FACILITY: Grand Gulf Nuclear Station, Unit 1  
LICENSEE: System Energy Resources, Inc. (SERI)  
SUBJECT: SUMMARY OF FEBRUARY 14, 1989 MEETING WITH SERI REGARDING PIPE SUPPORT CALCULATIONS

## TORSIONAL LOADS ON PIPE SUPPORTS

OPERATIONAL MODE DIAGRAM  
 SKETCH 2 - NORMAL OPERATION  
 THRU RHR 'A' LOOP

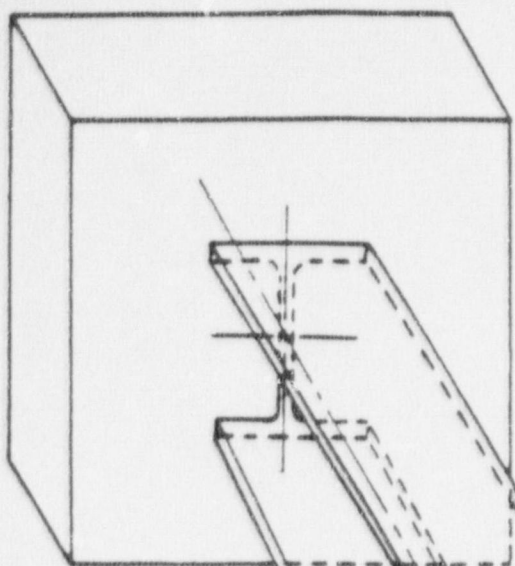
o	System Scope (Figure 1)	
o	Pipe Support Scope:	
o	New Q supports	33
o	New Non-Q supports	4
o	Q Supports (load increase)	29
o	Q-supports (No load increase)	70
o	Non-Q supports (load increase)	18
o	Non-Q supports (no load increase)	10
		<hr/>
	TOTAL	164

(FIGURE 2)

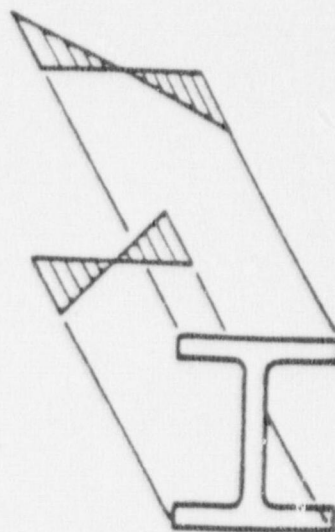
- o Torsional Loads on Open Sections (Figure 2)
- o Consideration of Warping Shear Term

- o Agree that warping shear term not explicitly considered
- o However, calculations were considered acceptable:
  - o Simplified St. Venant pure torsion approach very conservative
  - o Warping shear term is a small effect
  - o Simplified St. Venant approach envelopes warping shear component
  - o Resulting calculations are conservative

- o Results:
  - o Code Allowable met in all cases
  - o Resultant open section shear loads reduced by a factor of 45% or more
  - o Conservatism of the original calculations confirmed
